Bay Arenac ISD Dining Room Addition
and Interior Renovations
Bay City, Michigan

ADDENDUM NO. 5

Date: September 18, 2026
TSSF Project # 2538

4 WALL SECTION
SCALE: 3/4" = 1'-0"

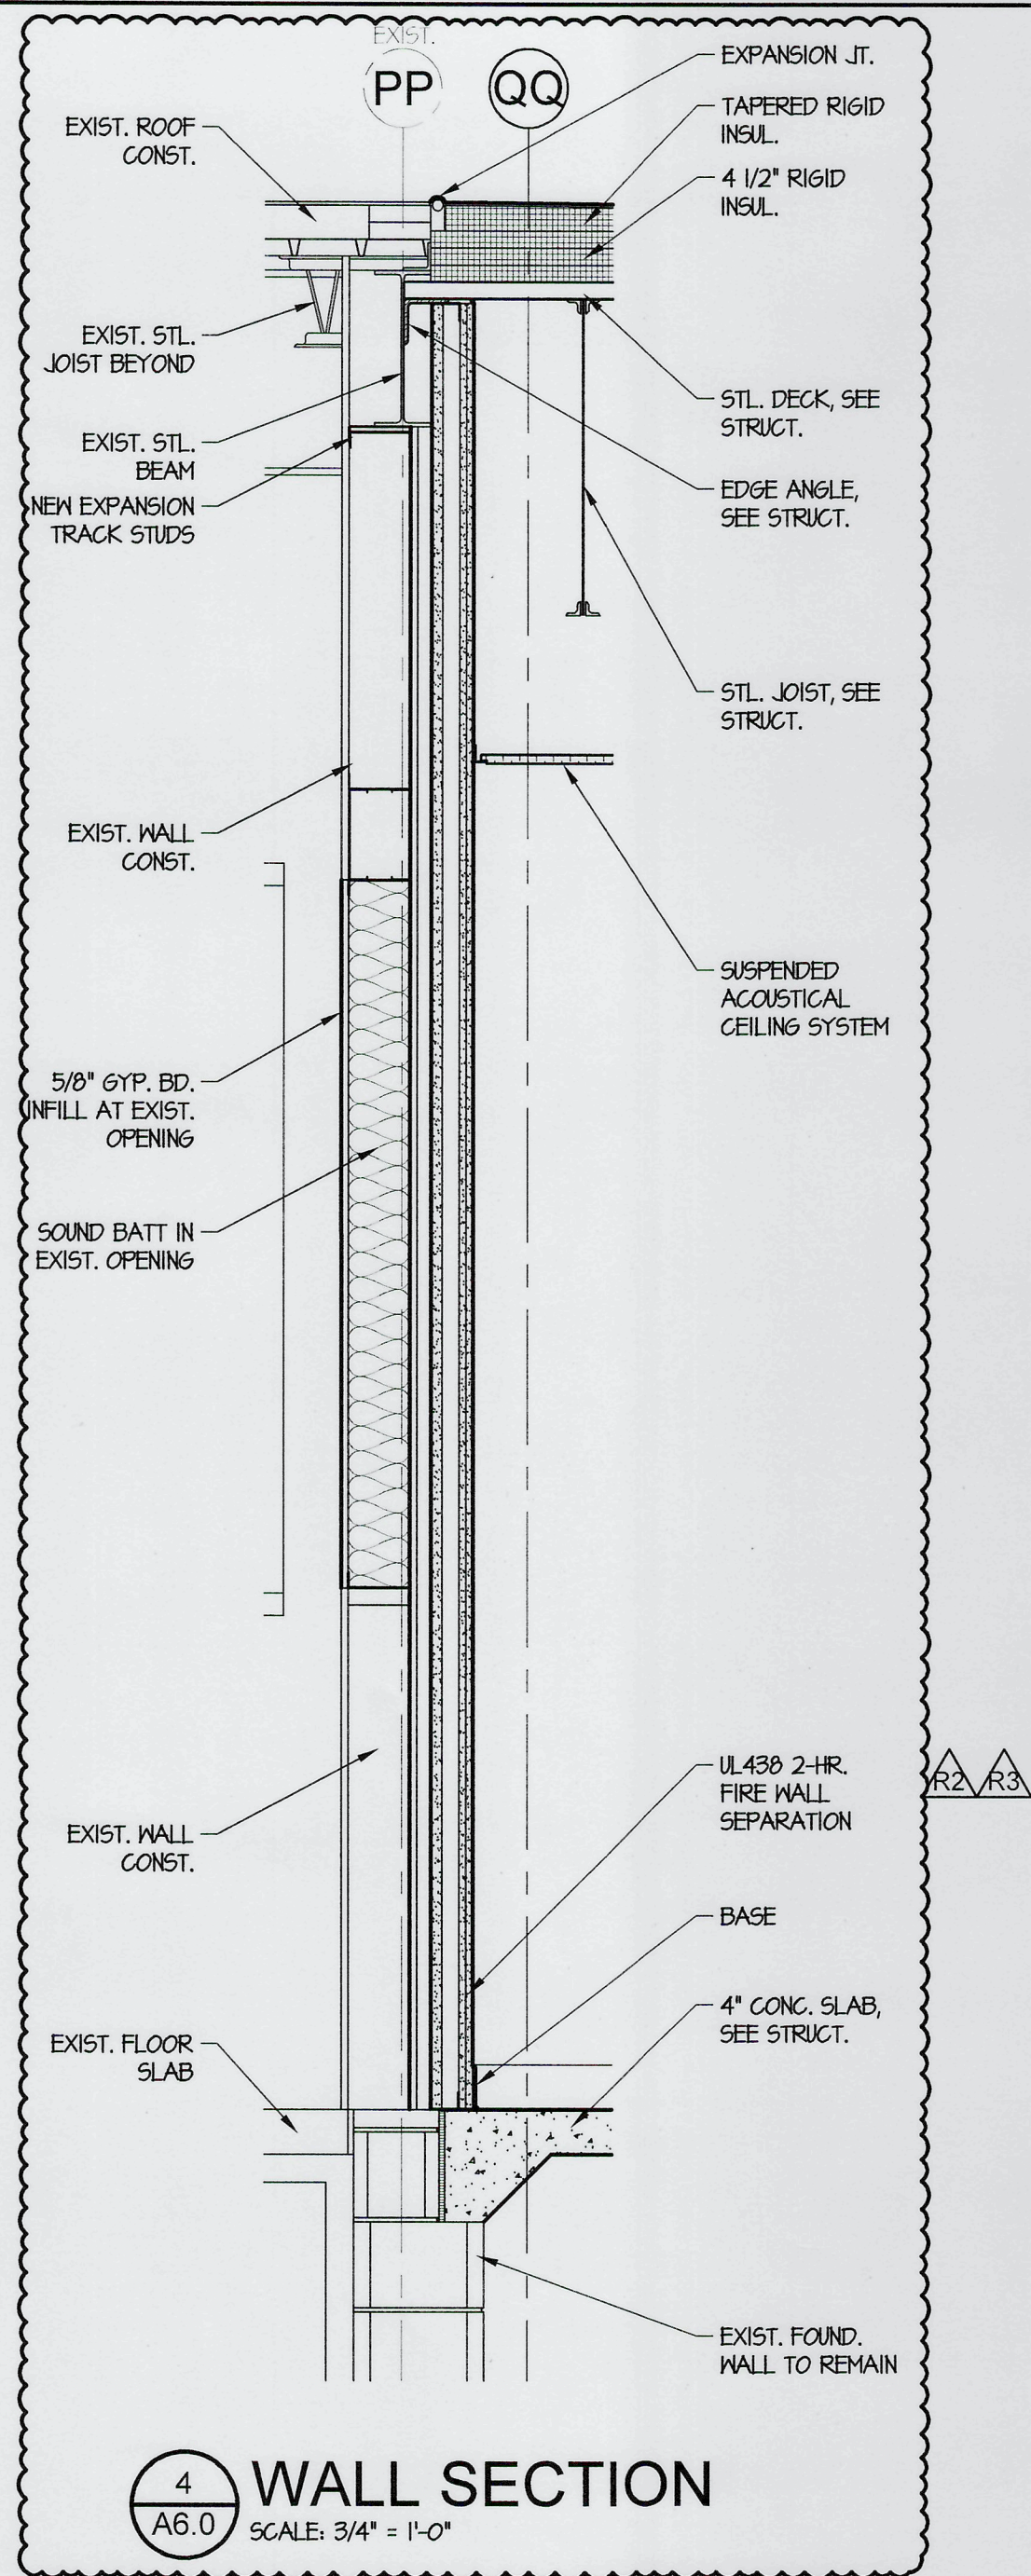
Item A3: **See revised sheet A6.0 (re-issued):** See wall section 4/A6.0. Revised note to say "Fire Wall".
